ACP-2021-025

Group of TDAs connecting Orkney and Shetland Islands for SATE UAS operations

Summary of Stakeholder Engagement

Figure 2 The proposed TDA is divided in 5 segments

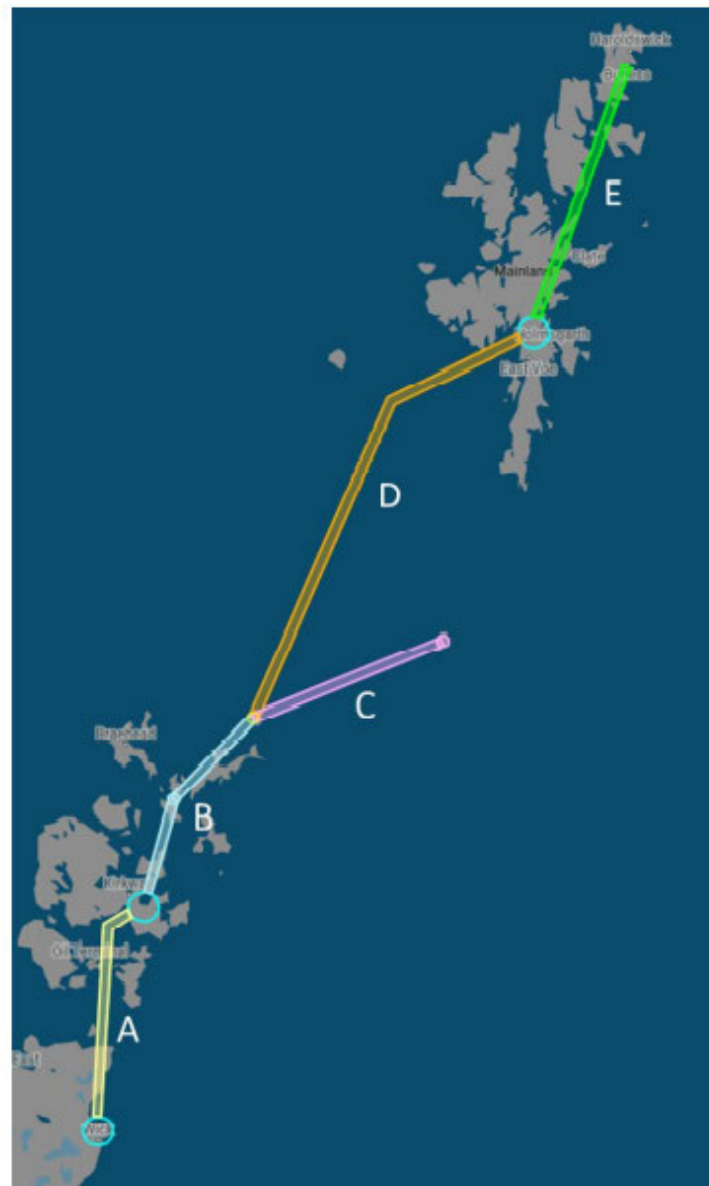
The initial proposal (Figure 2) identifies five different segments:

Changes to geometry, altitudes and schedule can be made upon analysis of feedback from all airspace Stakeholders. The earlier we receive this feedback, the easier it is for us to come up with a solution that causes the least impact on everybody's operations. Stakeholders will be informed of these changes and opportunity to provide additional comments will be provided.

- Change the height of segments A and B to 1500 ft AMSL. This will help provide vertical separation from IFR traffic and helicopter operations.
- Change the geometry of segment A to be clear of instrument departure/approach procedures at Kirkwall and keep away from Lamb Holm airfield.
- Change the geometry of segment B to clear 2 NM airspace around Sanday Airfield.
- Liaise with local Air Traffic Services to provide DAAIS or DACS for the different TDA segments.

Figure 3 TDA Segment A, Wick-Kirkwall, Proposed Design

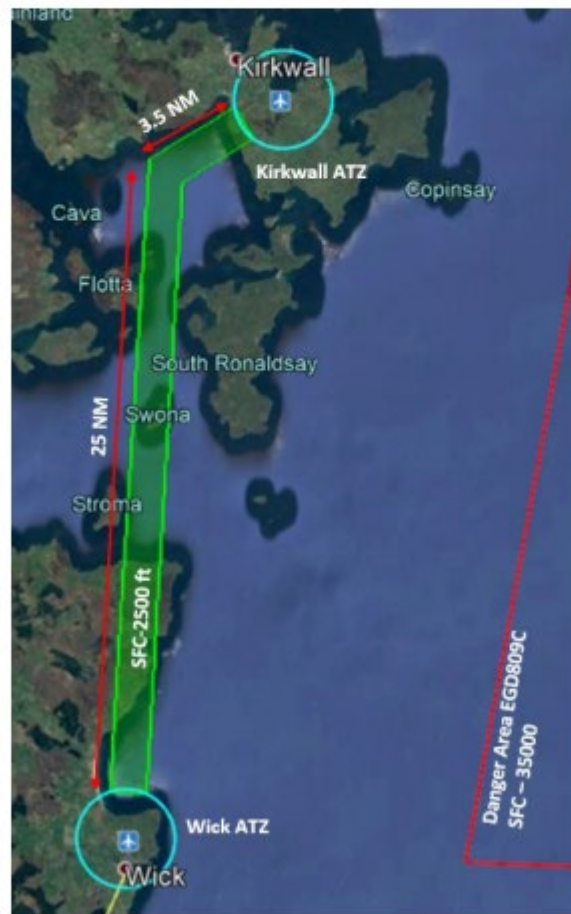
The proposed TDA provides a corridor 1.54 nm wide connecting the Aerodromes' Traffic Zones (ATZ) of Wick airport and Kirkwall airport and extends from surface (SFC) to 2500 ft. As shown in Figure 3, the corridor is split into two legs with the aim of avoiding busy areas above local airfields. One leg leaving Wick ATZ is 25 NM and the second leg entering Kirkwall ATZ is 3.5 NM.

The correct data for segment A is:
